DEPARTMENT OF THE AIR FORCE
AIR FORCE REAL PROPERTY AGENCY

SUBJECT: NYSDEC Spill Number: 9707954
Apron 1 Bioventing Final Work Plan Including Phase II Insert
Project Number: JREZ 2000-2007

**APRON 1
ENVIRONMENTAL CLEANUP
WORK PLAN
PROJECT NO. JREZ 2000-7007
GRIFFISS AIR FORCE BASE, NEW YORK**

APRON 1 BIOVENTING SYSTEM INSTALLATION - PHASE II

GRIFISS AFB
 ROME, NEW YORK
 SITE PLAN AND PIPING LAYOUT
 REMEDIAL ACTION
 APRON 1 & NOSEDOCKS 1 & 2

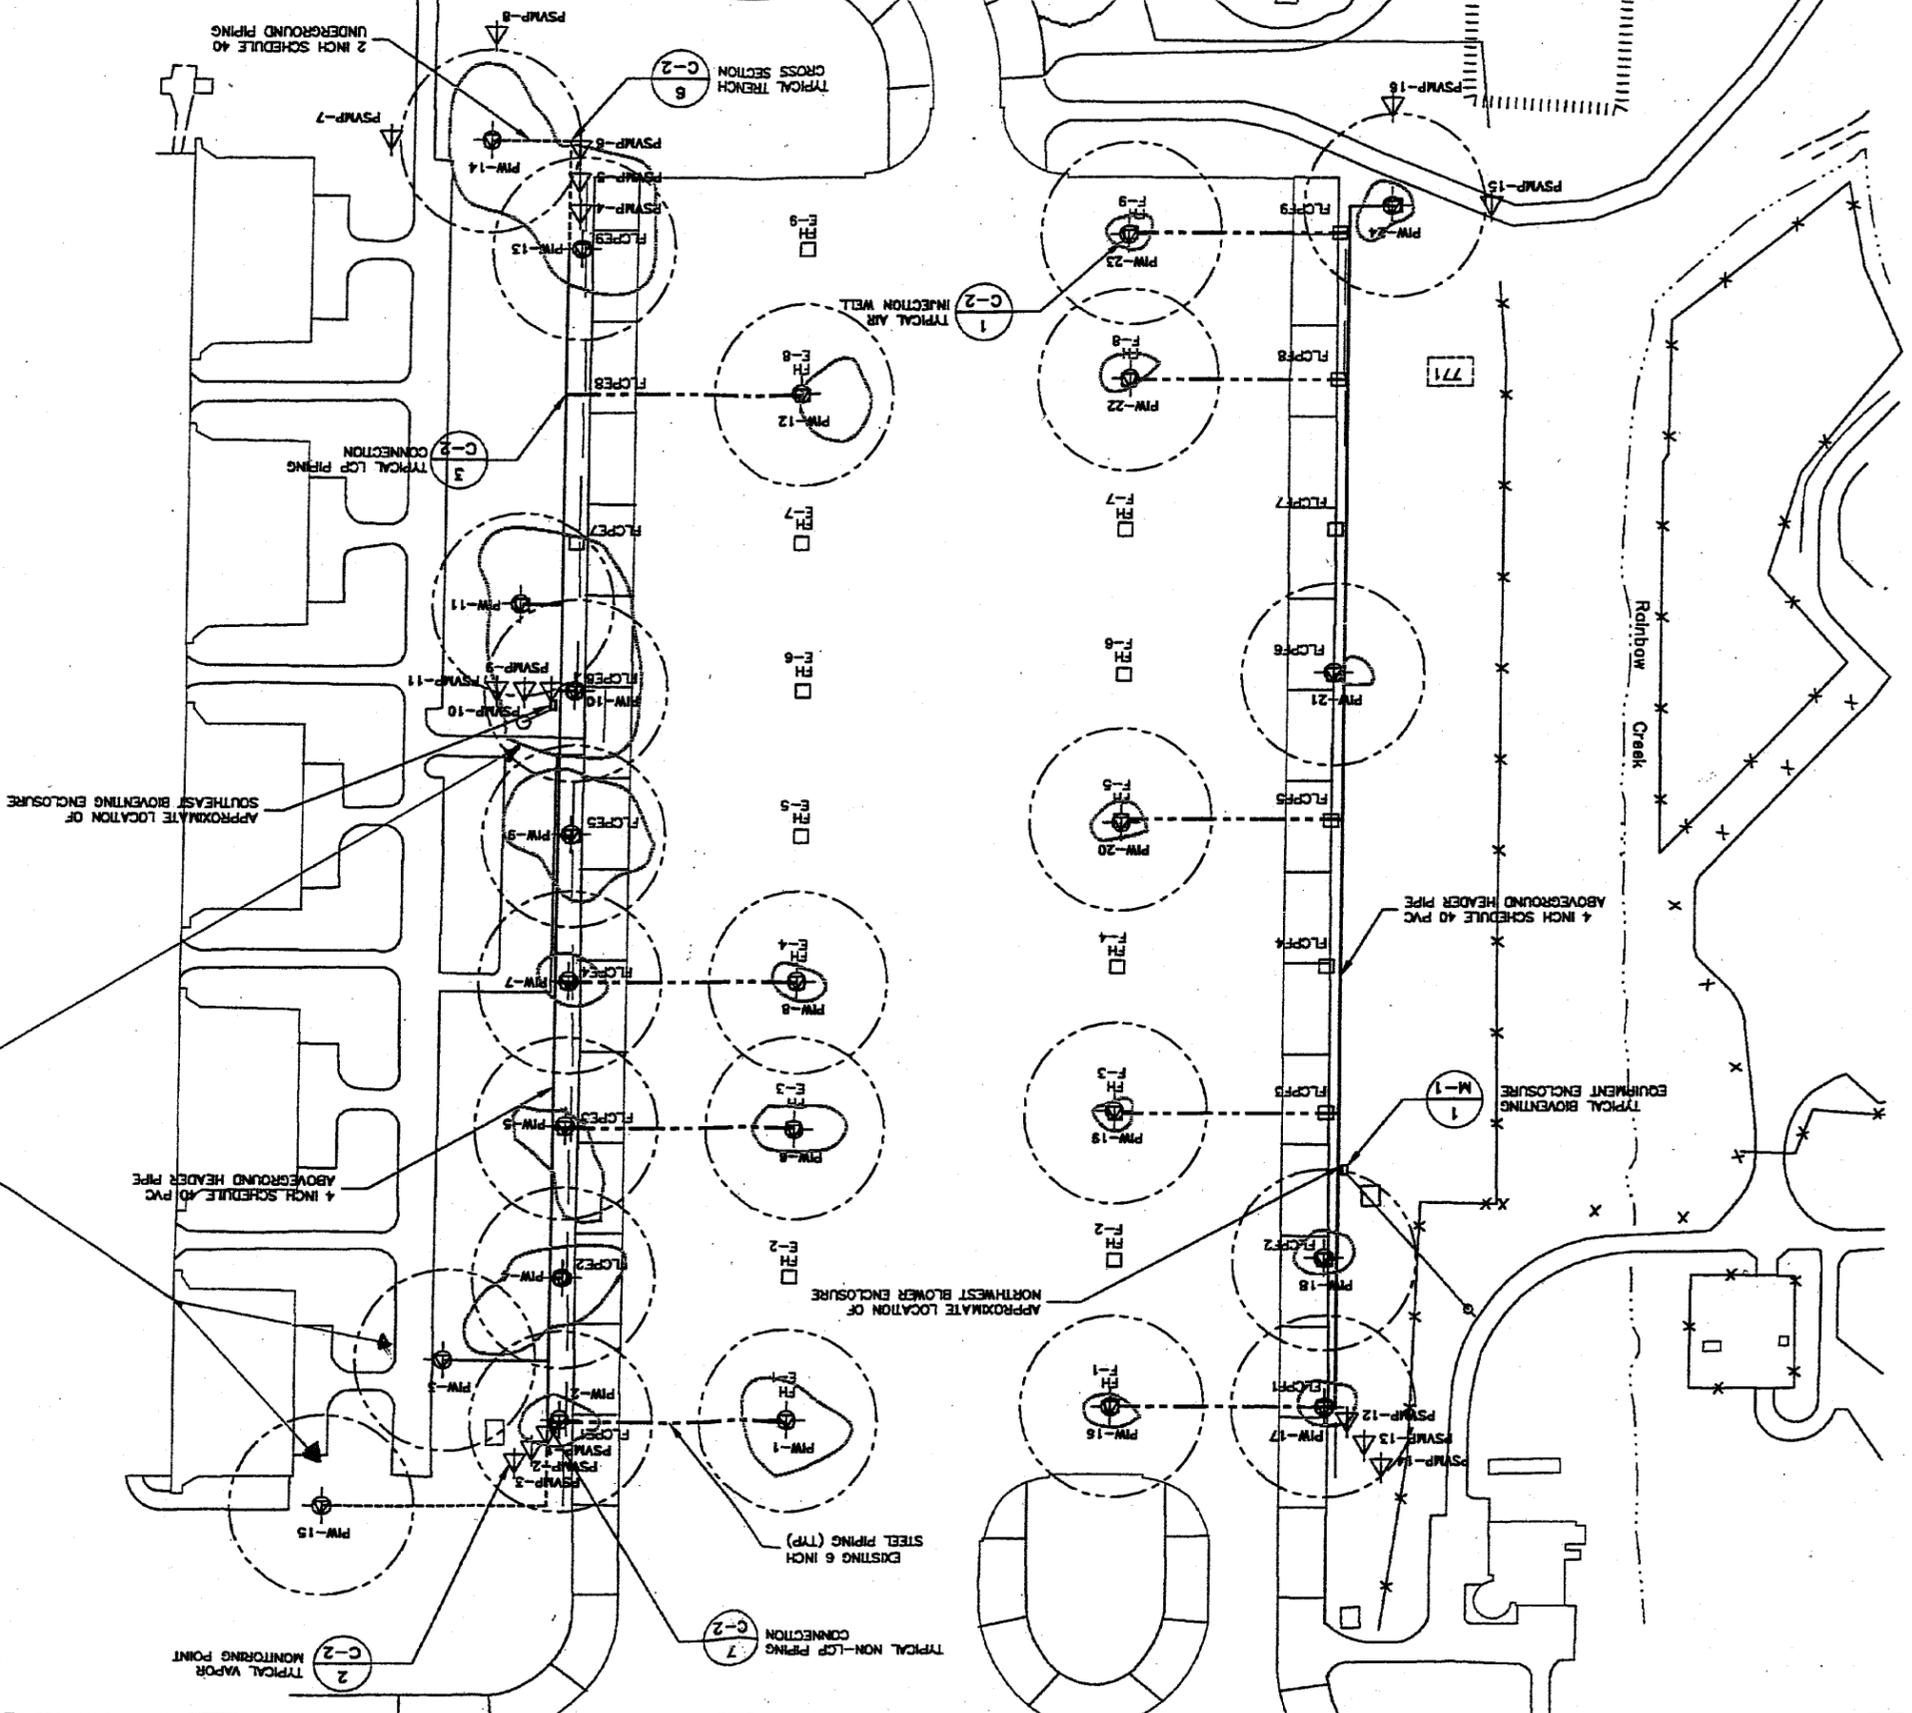
In May 2003, Parsons excavated and disposed of, off-site, approximately 530 tons of contaminated soil from the LCP E-6 site. The analytical results of the confirmatory soil samples collected from the sidewalls and bottom of the excavation, indicated that there were no exceedances to NYSDEC TAGM 4046 dichlorobenzene cleanup criteria as shown in Table 2.1 of the closure report (Parsons; Decision Document/Closure Report LCP E-6 (Draft Final) August 19 2003). The excavation was backfilled with clean soil and restored. The installation of an additional pressure injection well (PIW-10) is proposed to remediate remaining petroleum contamination surrounding the LCP E-6 excavation.

Based on the conclusions and recommendations in Section 3.2.2 of the Informal Technical Informational Report (FPM; Draft February 2003), Parsons proposes to extend the existing Apron 1 bioventing system by installing two additional pressure injection wells (PIW-3 and PIW-15) in the vicinity of former OWS 5730.

NOTE:
 Proposed Apron 1 Phase II
 pressure injection wells PMW-3
 and PMW-15 at OWS 5730
 and PMW-10 at LCP E-6
